Final Safety Evaluation Report for Combined Licenses for  
Levy Nuclear Plant Units 1 and 2

U. S. Nuclear Regulatory Commission  
Office of New Reactors  
Washington, DC 20555-0001

May 2016

This final safety evaluation report<sup>1</sup> (FSER) documents the U.S. Nuclear Regulatory Commission (NRC) staff's technical review of the combined license (COL) application submitted by the applicant for the Levy Nuclear Plant (LNP) Units 1 and 2. The applicant, Duke Energy Florida, LLC, was formerly identified as Duke Energy Florida, Inc., and Progress Energy Florida, Inc.

Figure 2.5.2-6. Mean Hazard Curves for the NMSZ (New Madrid) and Charleston Sources of Repeated Large-magnitude Earthquakes (RAI 02.05.02-18 Figure 1)

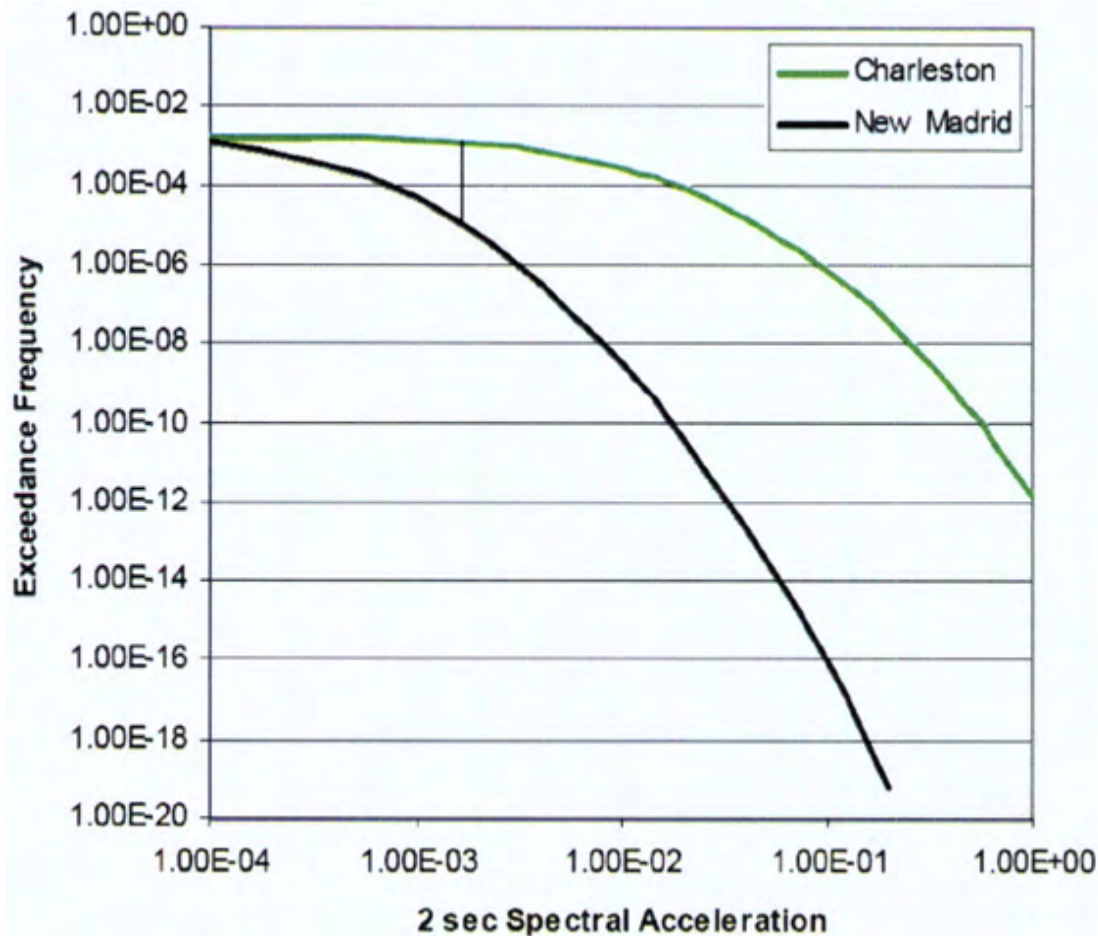
In response to RAI 2.5.2-18, the applicant provided the staff with its evaluation results of the effect of NMSZ to the hazard at the LNP. SER Figure 2.5.2-6 compares the 2-second mean spectral acceleration hazard of repeated large-magnitude earthquakes for the NMSZ to that computed for earthquakes in the region of Charleston, South Carolina. The Charleston source was included in the LNP PSHA. SER Figure 2.5.2-6 illustrates that the mean hazard from the NMSZ is less than 1 percent of the hazard from the Charleston source for the 2-second spectral acceleration. The NMSZ is a distant source zone (> 1000 km (> 620 mi)) from the LNP Units 1 and 2 site. The effect of a large-magnitude earthquake on the site at such distances would be greatest at low frequencies, for example at 0.5 Hz equivalent to the 2-second period used by the applicant in SER Figure 2.5.2-6. Since the hazard of the NMSZ at the LNP Units 1 and 2 site is less than 1 percent of the Charleston source at low frequencies, the NMSZ contribution to the total hazard at the LNP Units 1 and 2 site will be less than that shown in SER Figure 2.5.2-6. Therefore, the NMSZ is not a significant contributor to the seismic hazard at the LNP Units 1 and 2 site. Based on the results of the applicant's testing of the NMSZ, the staff concludes that the NMSZ does not contribute significantly to the hazard at the LNP Units 1 and 2 site and, therefore, does not need to be included in the LNP PSHA. The staff considers RAI 2.5.2-18 resolved.

**Figure 2.5.2-8. Increase in Aleatory Variability for Periods Longer than 2.0 Seconds Based on the PEER-NGA Ground Motions (RAI 02.05.02-08 Figure 1)**

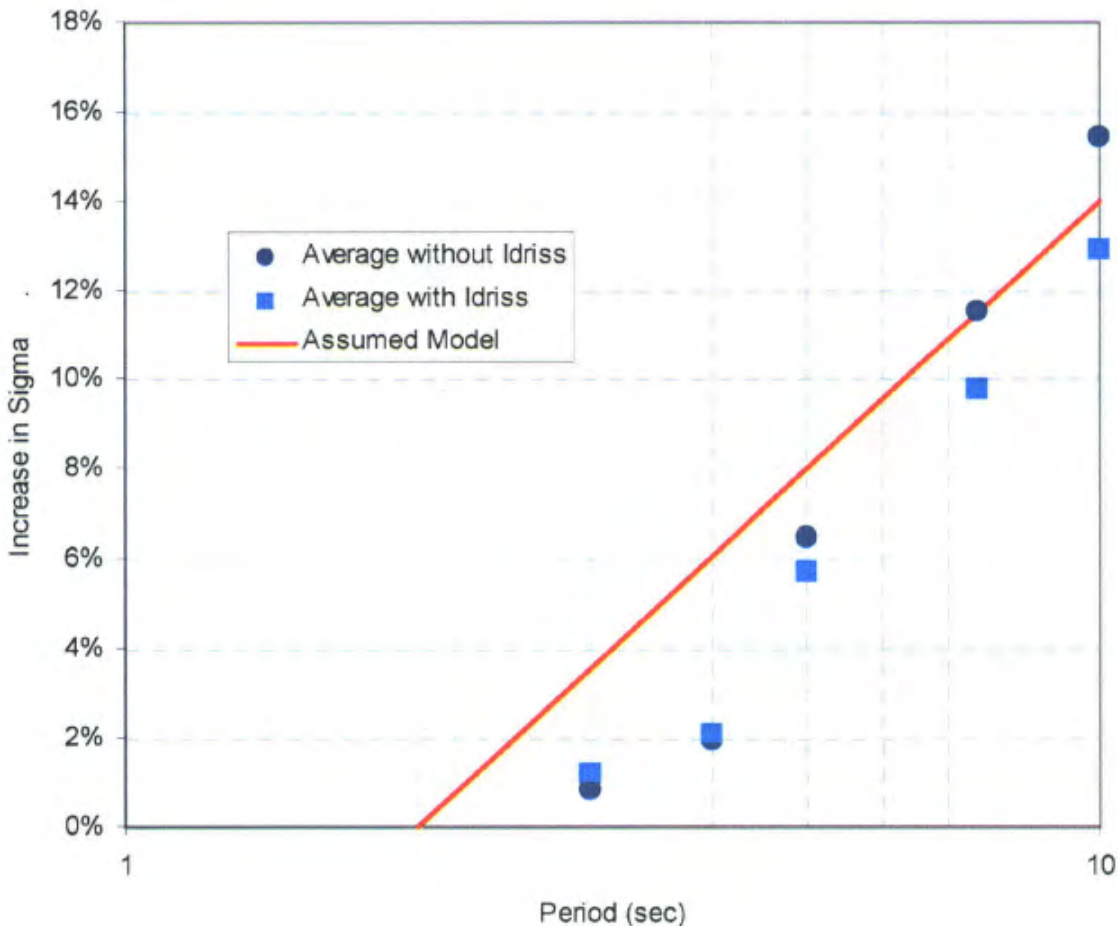
spectral frequencies between 0.1 and 100 Hz, the applicant used a combination of relationships from a number of references. In RAI 2.5.2-8, the staff asked the applicant to identify the sources of relations it used and to illustrate the dependence between the aleatory variability and frequencies that the applicant adopted. In its response, the applicant provided the justification of relations used as illustrated in SER Figure 2.5.2-8. The figure illustrates the relationship between aleatory variability (increase in Sigma) and frequency (or Period). The applicant provided the requested information; therefore, the staff considers RAI 2.5.2-8 resolved.

**Figure 2.5.2-10.** Seismic Wave Velocities Measured Using the Cased P-S Suspension Logging Methodology (Black Lines and Symbols) and Using Downhole Layered Models (Line and Symbols Labeled DH) (RAI Figure 02.05.02-1-02)

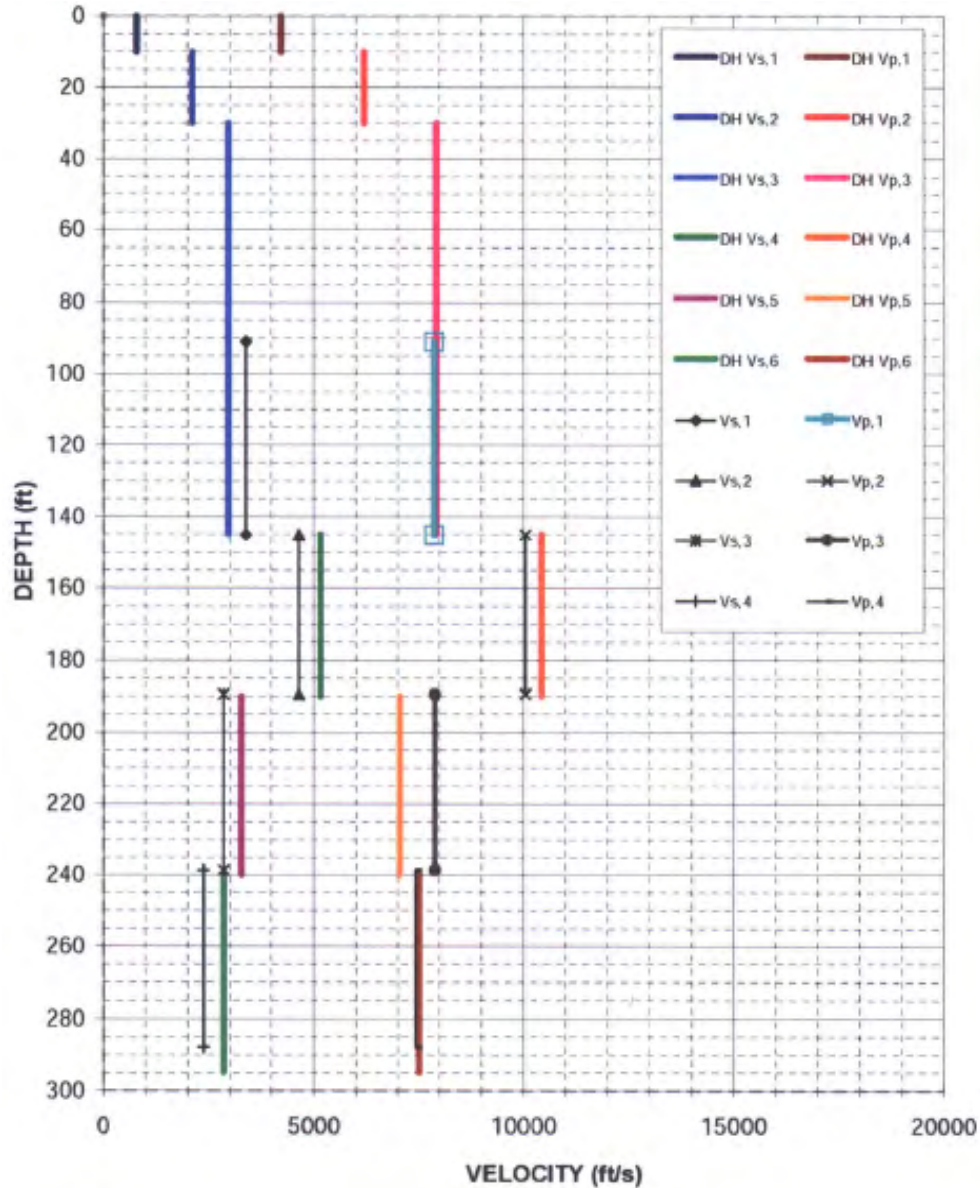
Regarding the pre- and post-grouting seismic wave velocities, the staff concludes that after the permeation grouting program is concluded, the LNP Units 1 and 2 site will maintain its site uniformity and  $V_s$  characterization as described in the LNP Units 1 and 2 COL application. As shown in SER Figure 2.5.2-9, the pre- and post-grouting measurements are within the expected precision of the P-S suspension logging method, and the change in  $V_s$  from pre- to

post-grouting is within the standard deviation for the upper layers of the Avon Park Formation. Additionally, SER Figure 2.5.2-10 shows that both the cased and uncased P-S suspension logging methods produce similar seismic velocities versus depth and the comparison illustrates that the casing used in the borehole measurements did not systematically affect seismic wave velocity measurements during P-S suspension logging data collection. These comparative results of the cased P-S suspension logging and downhole layered models, assure the staff that the cased borehole piping did not significantly affect the applicant's seismic wave measurements. The staff considers RAIs 2.5.2-1 resolved.

**Figure 2.5.2-11.** An Example of the Applicant's Scaling of Input Acceleration Time Histories Using the Parkfield Earthquake, San Luis Obispo 234° Component to Match the  $10^{-4}$ , HF, DEM Earthquake Target Spectrum (RAI 02.05.02-12 Figure 2)

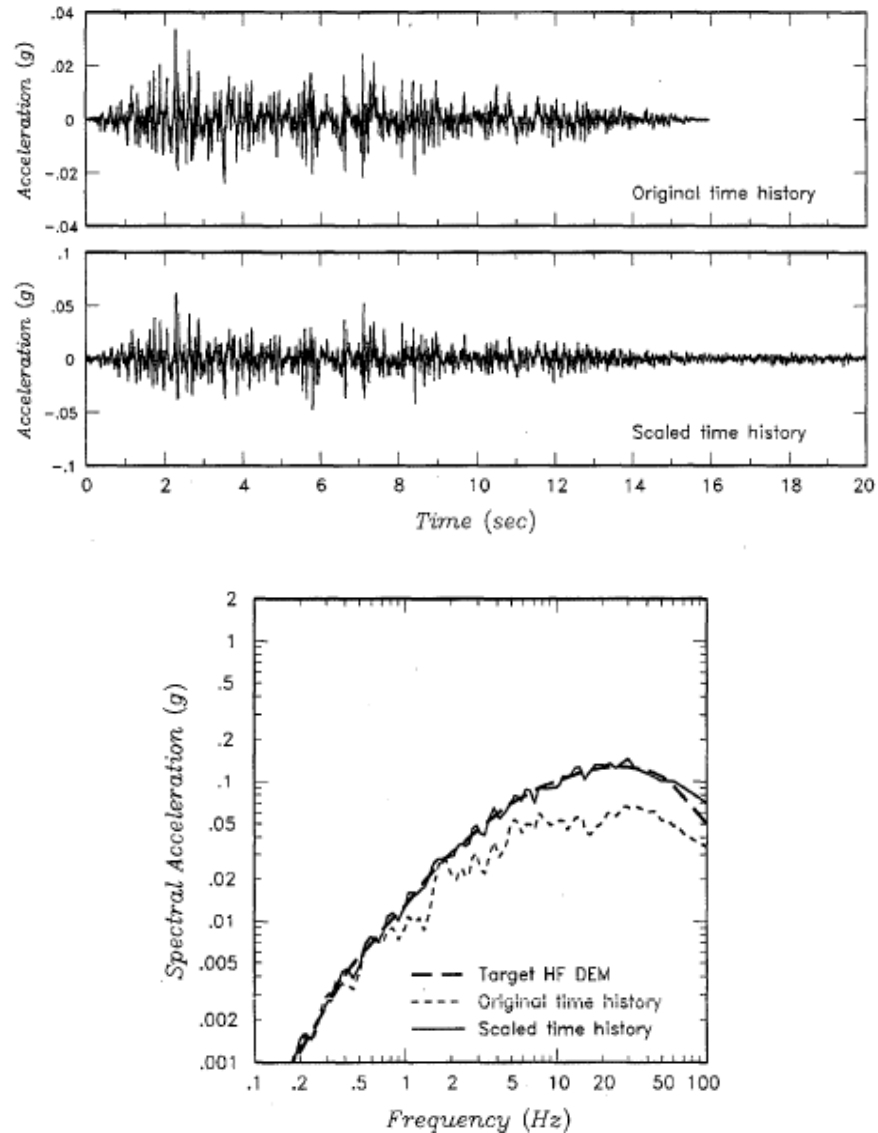
In response to RAI 2.5.2-12, the applicant provided a list of the specific recordings used and recording parameters such as date, time, magnitude, station, and distance from event to station, among others. The applicant chose recordings from active tectonic regions and modified the spectra to have the general characteristics expected for rock site motions in the CEUS. Regarding the scaling of the input response spectra, the applicant explained that it first defined a target spectrum for each controlling and deaggregation earthquake. Second, the applicant scaled the individual input acceleration time histories in the frequency domain to match the target spectra. SER Figure 2.5.2-11 shows the time history from NUREG/CR-6728 and its response spectrum, the target spectrum, and the scaled time history and its response spectrum. After reviewing the specific list of the acceleration time histories used as input motions the staff concludes that the applicant demonstrated appropriate use of the input acceleration time histories and of the scaling process, because the applicant used inputs and scaling consistent with the controlling and deaggregation earthquakes. The staff finds the applicant's response to RAI 2.5.2-12 adequate and considers this RAI 2.5.2-12 resolved.

**Figure 2.5.2-12. Results of the Staff's Confirmatory Analysis**

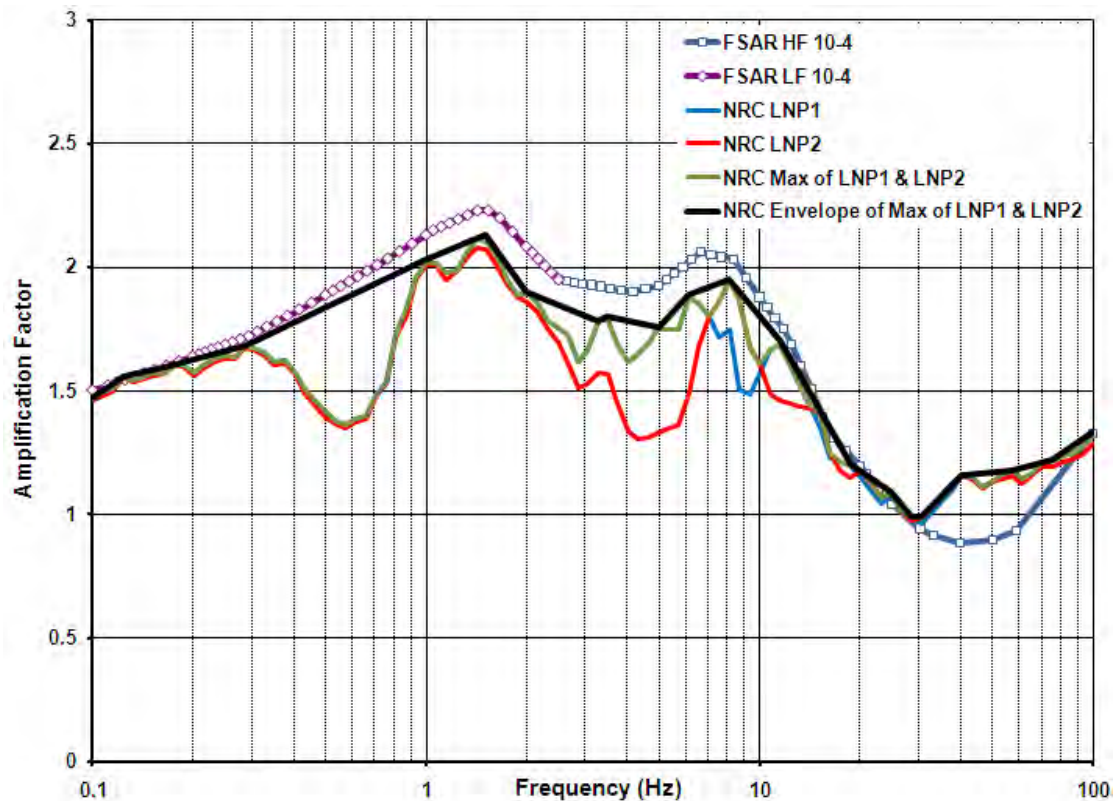
functions in SER Figure 2.5.2-12. In the frequency range 0.1 to 30 Hz and 80 to 100 Hz (PGA), the applicant's site amplification functions are equal or exceed the staff's site amplification. The staff's site amplification function exceeds the applicant's in the frequency range of 30 to 75 Hz. This exceedance is not significant because of the limitations of methods used, where the EQL method produces accurate results up to the frequencies of 25 Hz. Furthermore, GMRS calculated using this AF is still much lower than the CSDRS. Therefore, the staff concludes that in the frequency range significant to a reactor's structures, systems, and components, there are no significant differences between the staff's and the applicant's calculated amplification functions for the LF and HF,  $10^{-4}$  and  $10^{-5}$  hazard levels.

Figure 2.5.4-12.  $V_s$  Profiles in Boring AD-03 and Boring AD-20  
• (Excerpted from FSAR Figure 2.5.4.2-204B)

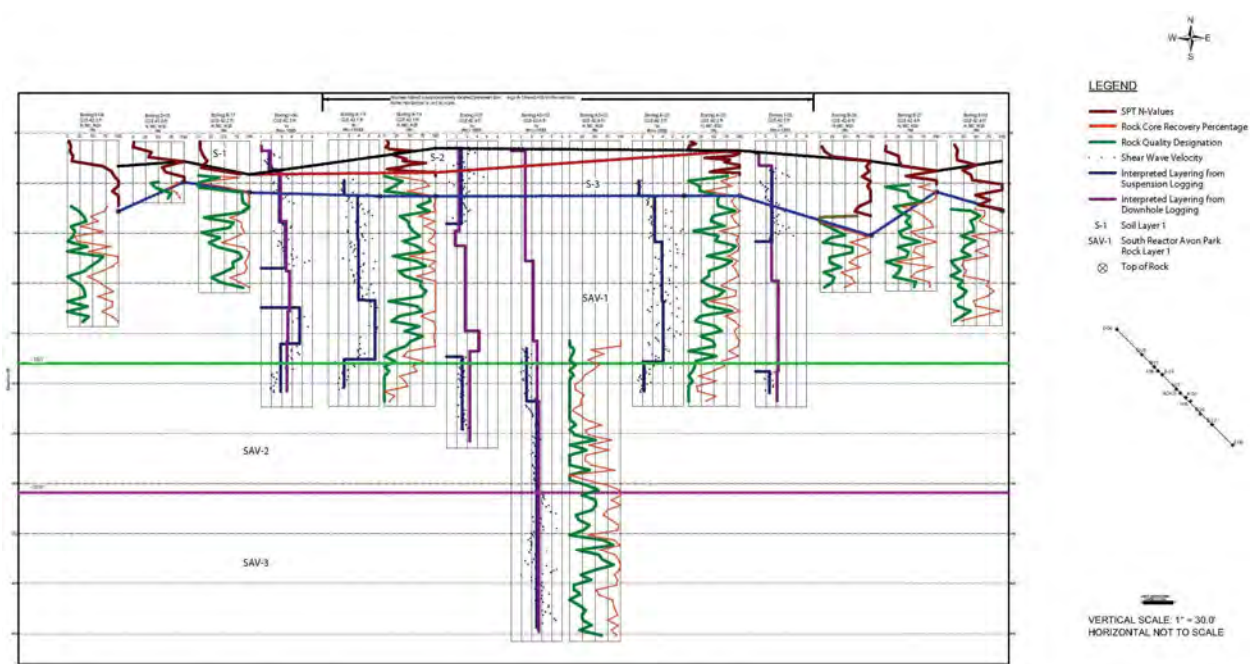
Figure 2.5.4-12 shows the  $V_s$  measured in borings along the N-S profile at LNP Unit 1. The blue dots represent individual  $V_s$  measurements and the blue line is the average of those measurements. Adjacent to the  $V_s$  profiles are plotted the sample recovery percentages and the RQDs determined during drilling that correspond to the  $V_s$  profiles. The lighter red line in this figure represents the sample recovery and the solid green line the RQD. The staff observed no consistent correlation between low recovery and  $V_s$ . From this figure, it is apparent to the staff that even at very low recovery rates, the  $V_s$  is typically greater than 457 m/s (1,500 fps). From the  $V_s$  data the staff concludes that the low recovery zones do not represent voids or soil-filled voids, which was later confirmed by the offset boring program. The staff, therefore, concludes that the maximum size of a void of 3 m (10 ft) diameter is conservative. Accordingly, RAI 2.5.4-6 is resolved.
